City of Coconut Creek InterOffice Memorandum

Subject: Casa Palma
Building Type III changes

RE: Casa Palma Apartment Development – 6112 SR 7, 33073

3 LEFT SIDE ELEVATION
SCALE: 1/8" = 1'-0"

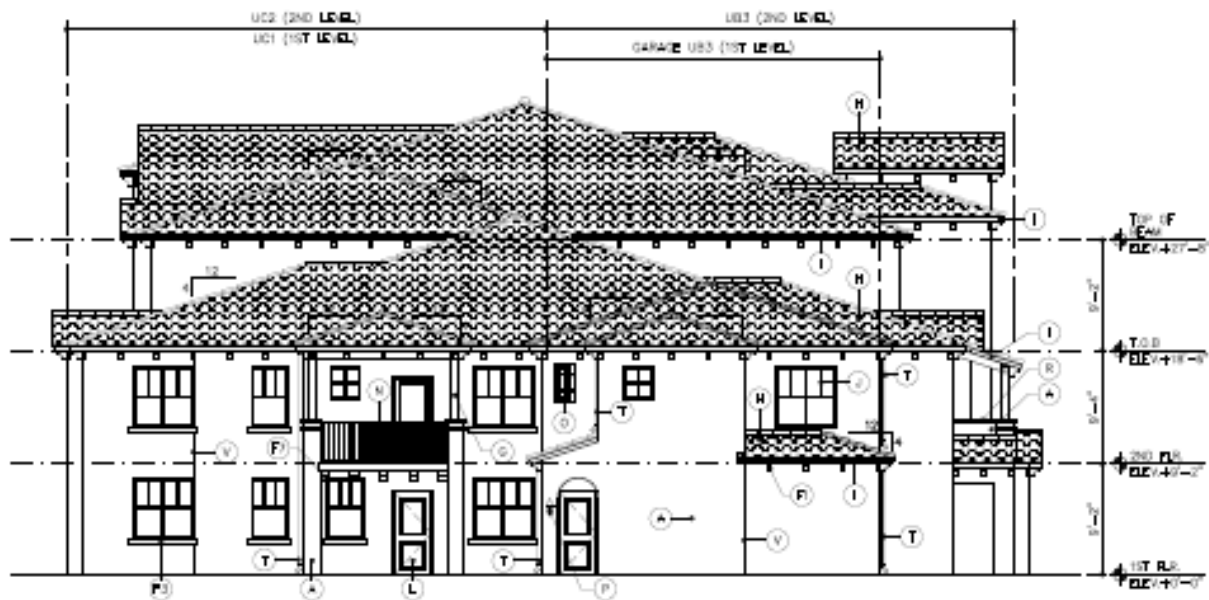
The first is the removal of two (2) windows and one (1) door previously proposed on the exterior garage wall, or left elevation. The removal will eliminate a potentially unsightly view into a garage and increase security by eliminating a remote ground floor access.

On October 24, during our second pre-permit plan review, Heidi Solano commented (Type III, permit # 12001687–12001689) that the “Left building elevation shown on sheet A3.3.1 is inconsistent with previously approved building elevation. Windows have been removed from the plans. Revise to match previously approved elevation”. In response to this comment, I spoke with Heidi on the telephone to discuss our reasoning behind the proposed change, as well as our concerns with the windows as previously drawn.

The windows previously shown in elevation occur on the outside of a vehicular garage. After much deliberation by ownership and management, it was concluded that it would be best to delete these, as they would otherwise be unsightly. We initially considered addressing the unsightliness (looking into a garage) with additional landscaping, but this alone could then present a potential security hazard, by offering a shielded, easy access point to ground floor, unoccupied space.

Following our discussion, Heidi and I were in agreement that the windows did not offer any meaningful value to the residential units, and could in fact become a security hazard, and recommended that I submit a memo for file. As such, we would like to request this amendment, and record it with this memorandum summarizing same.
